**Flood Control Project Maintenance  
Levee Inspections**  
**LMA District Cover Sheet**  
**Spring 2018 Levee Inspection Results**

**Reclamation District No. 0341 Sherman Island**

**Levee Inspection Report By Mile - Spring 2018**

Waterway	Bank	Unit Miles	Inspection Start/End	Inspector
Unit No. 01 Threemile Slough	Right	3.36	03/22/2018 03/22/2018	Keith Millard

Photo 1 of 3 : UCIP\_SP\_2018\_52254\_37654.jpg

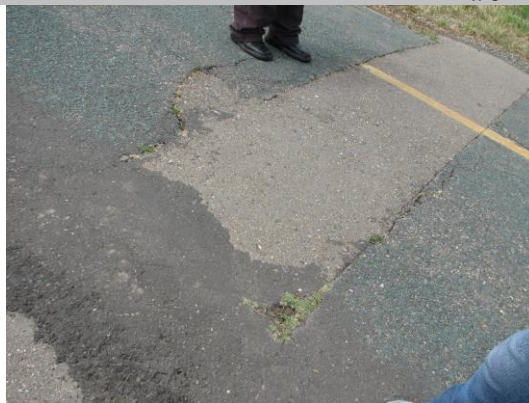
FS\_ID:52254  
DS\_ID:24111  
EP\_NO: 1477  
Repair Type: Non-Urgent  
Crossing Status: Found  
UCIP Comments: 07/06/2016 According to LMA Superintendent, Joel McElroy, the LS pipe section was replaced in about 2005 under the Three Mile Slough Project. No work was completed on crown or WS. (DWR UCIP - O. Magana)  
05/05/2009 Dense vegetation limits the inspector's visibility to identify signs of pipe failure (leaks) along the slopes. Recommend removing vegetation along pipe alignment to conduct proper inspection of structure and appurtenances. (DWR UCIP - O. Magana)  
FIELD\_STRUCT\_DESC: 10-inch steel irrigation siphon pipe through the levee, 1.8 feet below the crown. 10-inch pipe is encased in 12-inch corrugated metal conduit under crown. Pump is located on landside (LS). Air vent and metal distribution box with gate are located on the LS. Rock revetment placed along the waterside (WS) slope. A 30-foot section of pipe under the crown was replaced and encased in corrugated metal pipe (CMP) under unknown permit. (10-inch pipe authorized under Permit No. 1477, 1950 - L. J. Anderson) [Additional Reference(s): DWR Levee Log, 1992. USACE Sacramento O&M Manual Unit No. 101, February 1962, (HLM 0.50). LMA encroachment station (STA) reference based on Map of Evacuation Route, Reclamation District 341 Sherman Island by Wagner Bonsignore Consulting Civil Engineers, A Corporation dated July 2012, STA 149+00]

Cut along pipe alignment--unknown repair or maintenance date.

Photo 1 of 3 : UCIP\_SP\_2018\_22258\_37932.jpg

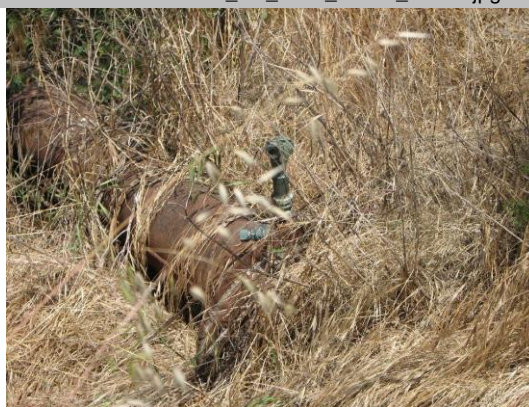
8-inch pipe and 14-inch pipe on waterward side.

Photo 1 of 3 : UCIP\_SP\_2018\_22264\_37965.jpg

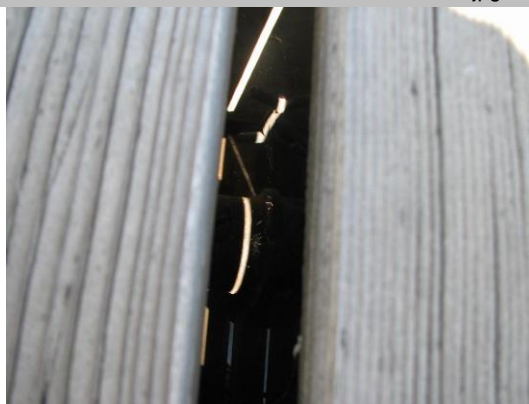
Comment Code					
Inspector Comment					
FS_ID:22264 DS_ID:24234 EP_NO: 892 Repair Type: Non-Urgent Crossing Status: Found UCIP Comments: Need to contact owner to determine status of crossing. Need date of last inspection and confirmation that crossing is still in operable condition. FIELD_STRUCT_DESC: 2 of 2: 12.75-inch steel gas line through the levee, 2.0 feet below the crown. Concrete cutoff wall around pipes at center of levee. Location marker on waterside (WS) slope. Concrete control box and valve pit on landside (LS) slope. Utility marker contact information includes Contact prior to Excavation call 1-800-227-2600 or Emergency Contact 1-800-811-4111. (12.75-inch gas line authorized under Permit No. 892, 1942 - Pacific Gas and Electric Company [PG&E]) [Additional Reference(s): DWR Levee Log, 1992. LMA encroachment station (STA) reference based on Map of Evacuation Route, Reclamation District 341 Sherman Island by Wagner Bonsignore Consulting Civil Engineers, A Corporation dated July 2012, STA 826+00] FS Date: 5/6/2009

Concrete box and marker located on near landward shoulder. Additional marker located at the levee toe.
